25 November 2011  
Ref BRI-LET-003

Queensland Floods Commission of Inquiry  
Level 30, 400 George St  
Brisbane  
QLD 4000

### **Review of Hydraulic Modelling**

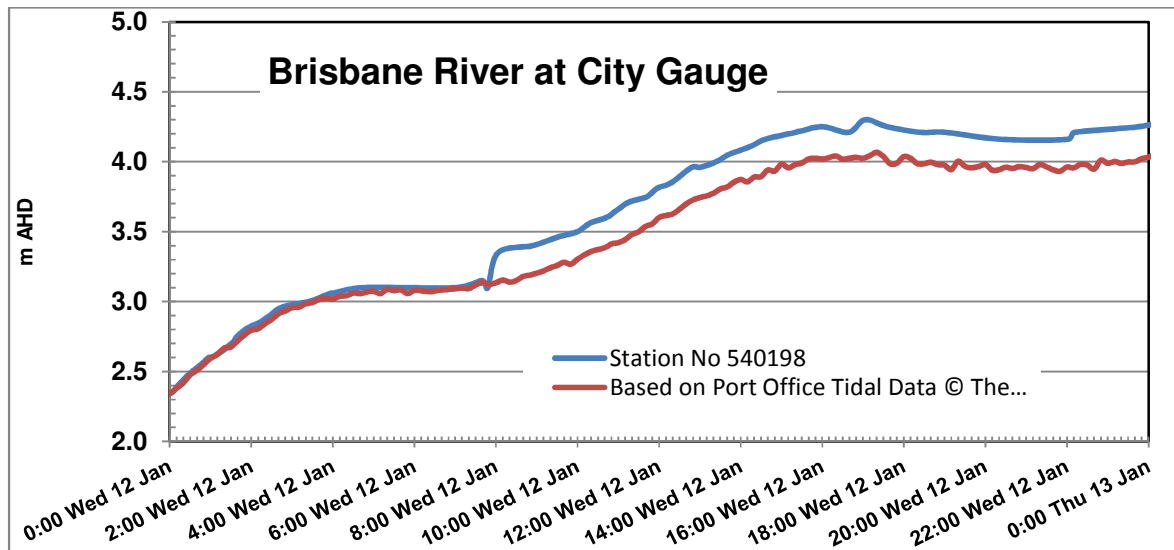
My comparison of the data from the two gauges over the period in question is shown in the plot below.

The above indicates that the gauge, Station Number 540198, experienced a displacement of approximately 250 mm between 07:48 and 08:09 Wednesday 12<sup>th</sup> January. Subsequently Station Number 540198 reported a river level approximately 200 mm higher than data provided by MSQ. Since gauge 540198 apparently records based on exceeding a particular change in level, it would seem that the displacement actually occurred close to the time of the recorded jump, i.e. 08:09 on Wednesday 12<sup>th</sup>.

The behaviour exhibited by the gauge Station Number 540198 is certainly not indicative of a natural event.
